No: CT/GJ/Manual

Sub: Addendum & Corrigendum Slip no. 5 to the Manual for Glued Insulated Rail Joints (1998).

**Addendum & Corrigendum Slip No. 5 of July 2012**

**Manual for Glued Insulated Rail Joints (1998).**

**FIGURE - 5**

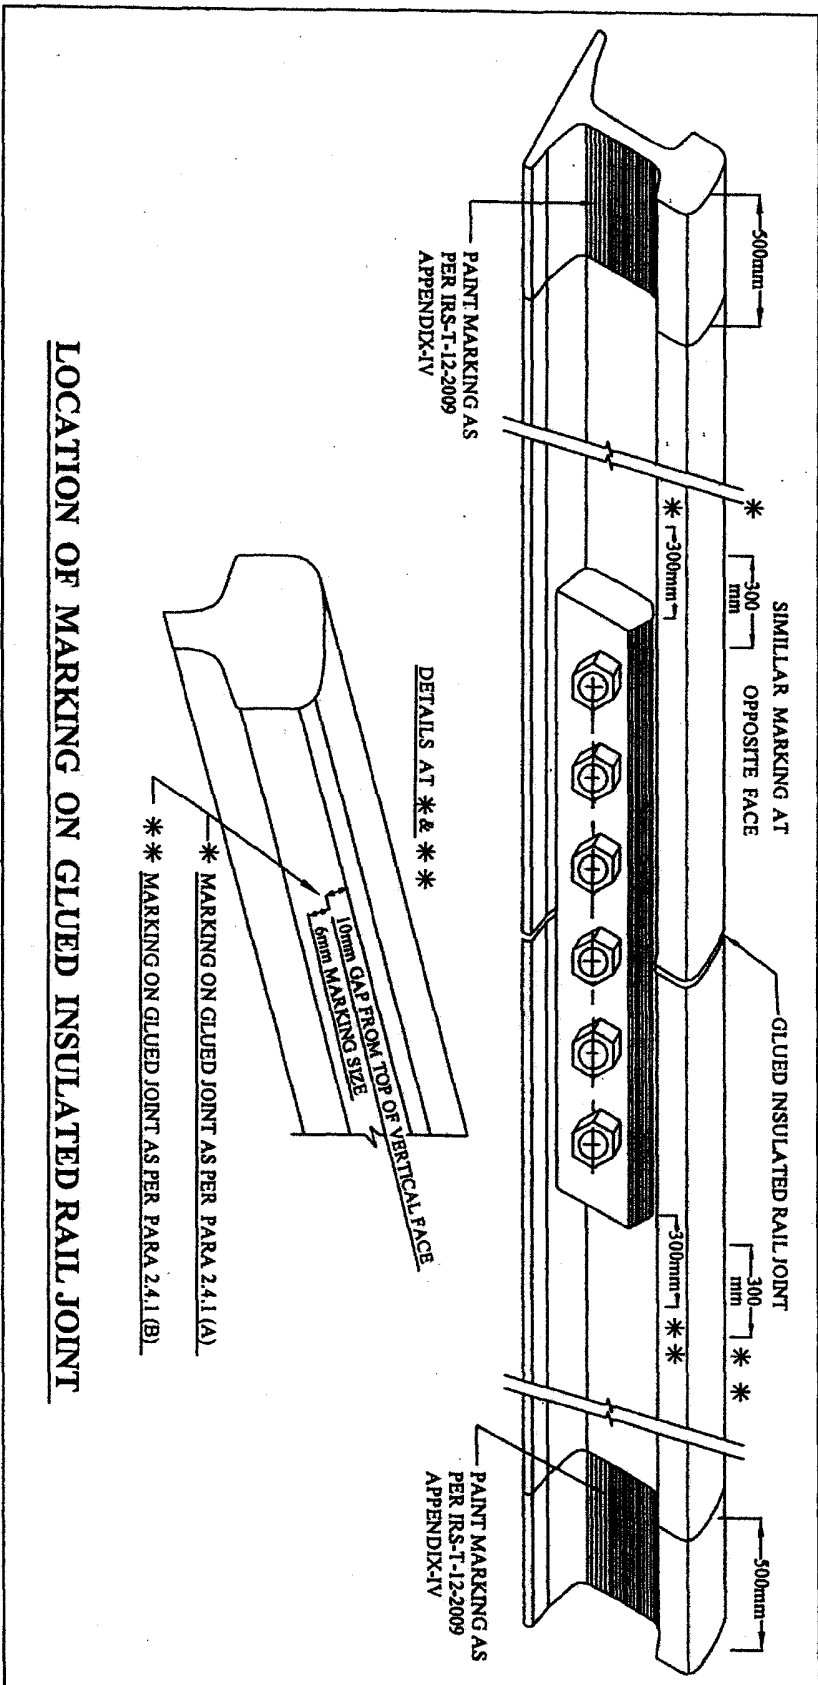
**(A) Marking of Glued Joints (by manufacturer)-** Every glued joint shall have distinctive mark indicating the glued joint number, month and year of manufacturing and the code of the manufacturer as shown below. This marking should be embossed on the gauge and non gauge face sides of the head of the rail of glued joint at 300 mm away from the one end of fish plate by punching without causing any damage to rail, in letters/digits of 6 mm height at a depth of 10mm from top of vertical face of rail, as indicated in figure 5.

**(B) Marking of Glued Joints (by inspecting authority)-** Every glued joint shall have distinctive inspection mark of inspecting agency. This marking should be embossed on the gauge and non gauge face sides of the head of the rail of glued joint at 300 mm away from the another end of fish plate by punching without causing any damage to rail, in letters/digits of 6 mm height at a depth of 10mm from top of vertical face of rail, as indicated in figure 5.

18. Figure- 5 of manual is replaced with as attached.
